# UNITED STATES PATENT AND TRADEMARK OFFICE

**Office Action Summary**

10/718,929

### DETAILED ACTION

Attachment #1

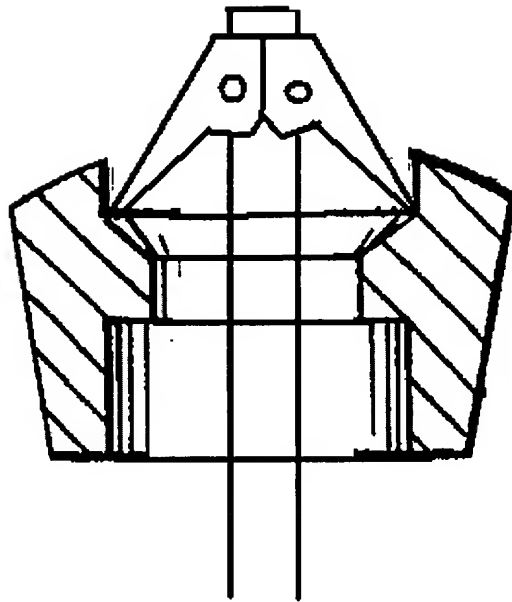
The applicant further argues that Hamlin fails to teach that the end of the toggle bar is adapted for locking engagement with the hole plug in the closed position.

As seen in attachment #1, Hamlin teaches a plug (36) that includes a recess that is capable of receiving and holding a toggle bar in a closed position. Therefore, the argument is not persuasive.
